FACPAC Contract Change Order Supplemental Information Form (Ref# 64863)

Change Order - Construction Manager-Adviser Edition

PROJECT (Name and Address)
 CENTRAL HARDIN HS PHASE II
 3040 LEITCHFIELD ROAD
 CECILIA, KY 42724

CHANGE ORDER NUMBER: 2-12
INITIATION DATE: 4/10/2026

A portion of Sheet A-371, Elevation H is shown below. A hand sketch relating to this ASI is labeled **Detail A** and shown on the next page.

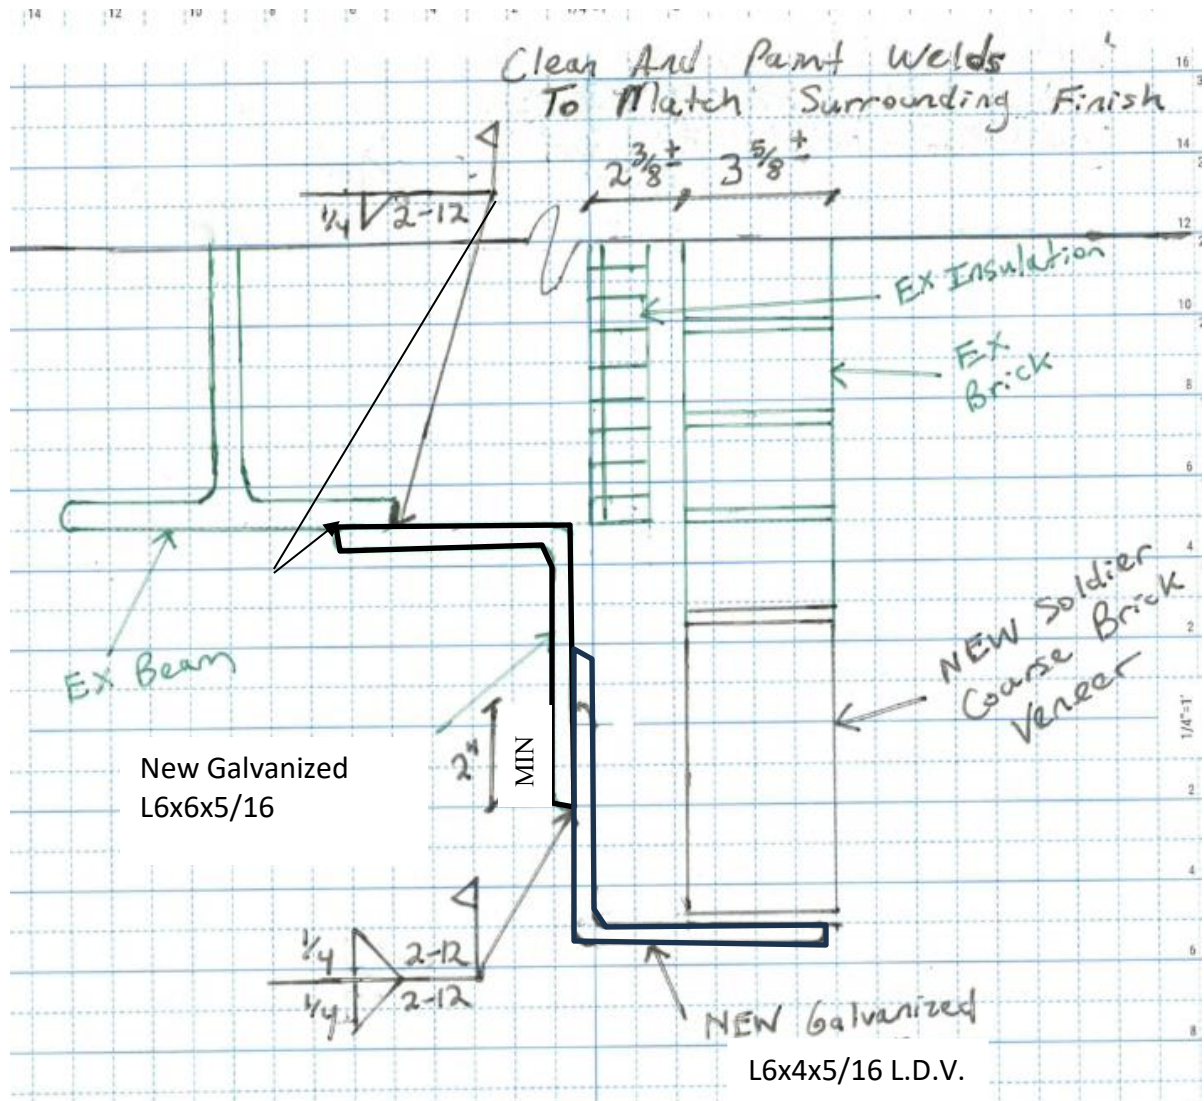
Field investigation and review of attached photos indicate that the existing edge angle supporting the brick veneer is in unsatisfactory condition due to water infiltration within the cavity. Water accumulation has led to significant corrosion of the edge angle, along with the failure of the top weld connecting this angle to an upper supporting angle that is welded to the existing structural beam. These welds are crucial for ensuring proper load transfer of the brick veneer into the structural beam and pose a threat to public safety in their current condition.

Contractor shall carefully remove and replace the existing soldier course of brick veneer and support angle system in four-foot segments, utilizing adequate shoring below the relief angle on each side of the cut-out sections to provide support to the brick veneer (and prevent overloading of the brick ties due to gravity selfweight). Remove brick soldier course and relief angle only over the width of the segment to allow the veneer above to arch between the shoring. Work may be simultaneously performed in a skip pattern of alternating 4 foot sequences; do not demolish adjoining sequence until new mortar is cured. New angles shall be galvanized, L6x4x5/16 (bottom) + L6x6x5/16 (top) and welded to the existing and to the existing steel beam with fillet welds. New flashing with a drip edge, weeps, and ties shall be installed. See **Detail A** for a detailed sketch of the proposed work. See **Appendix A** for elevation views of repair locations (to be three sides of terrace at Area J).

NOTE: NEW SOLDIER COURSE BRICK VENEER AND ANGLES MUST BE REPLACED IN 4 FOOT SECTIONS. WORK MAY BE SIMULTANEOUSLY PERFORMED IN A SKIP PATTERN OF ALTERNATING 4 FEET SEQUENCES; DO NOT DEMOLISH ADJOINING SEQUENCE UNTIL NEW MORTAR IS CURED. CONTRACTOR IS TO ENSURE ADEQUATE SHORING IS IN PLACE TO PREVENT THE TRANSFER OF ADDITIONAL LOAD INTO THE EXISTING BRICK TIES.

REFER TO WALL SECTION A/A-361

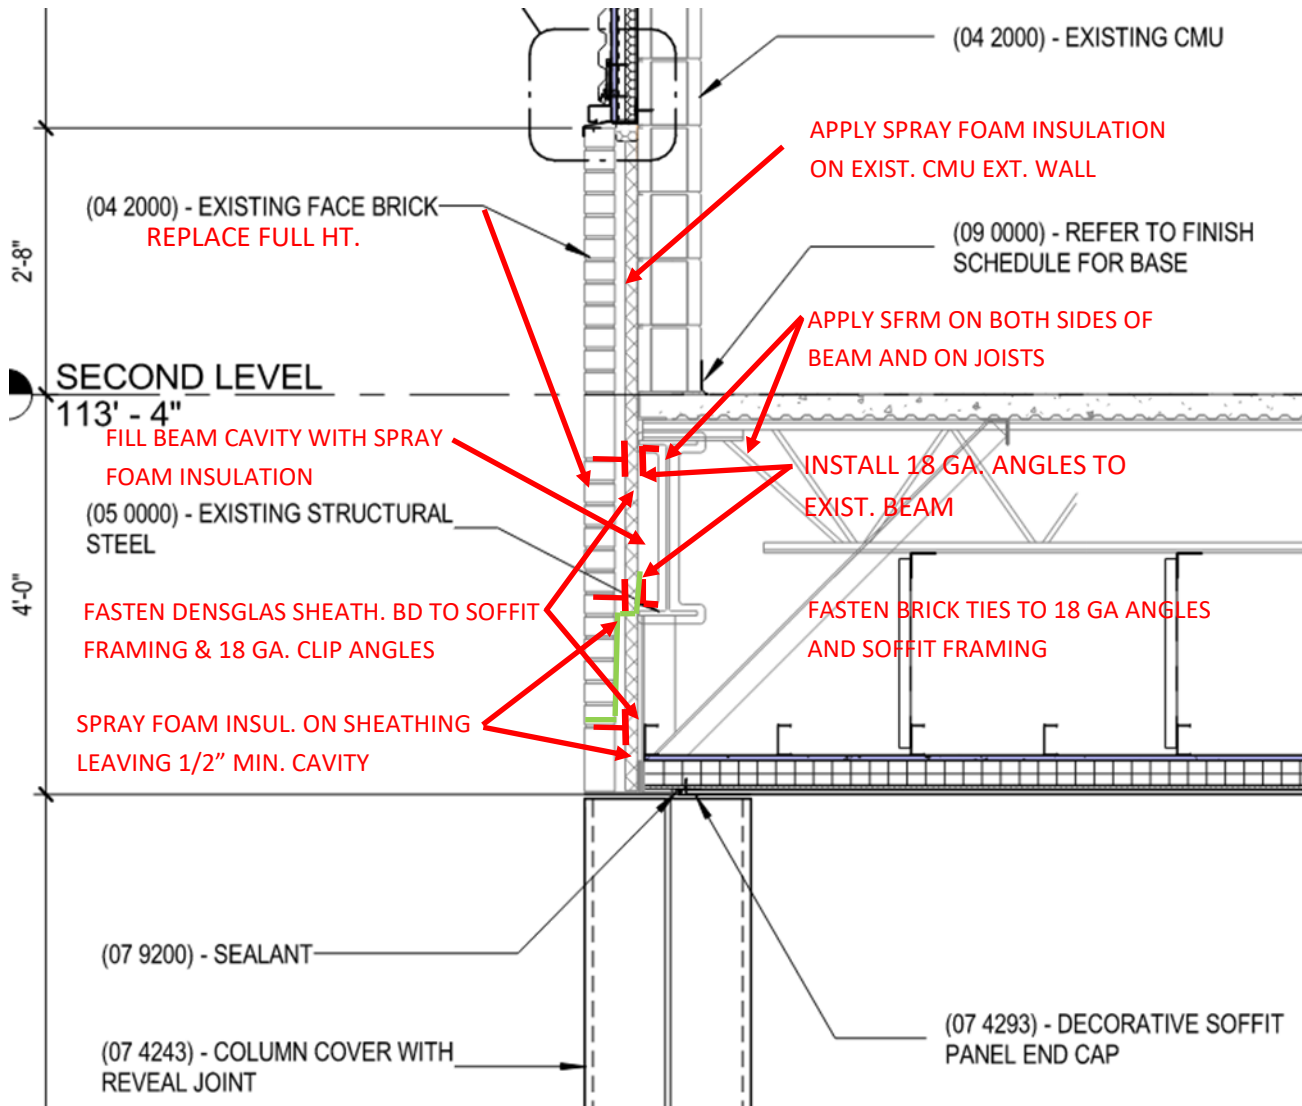
Provide pricing as noted in attached detail for brick and support angle at overhang in Area J.
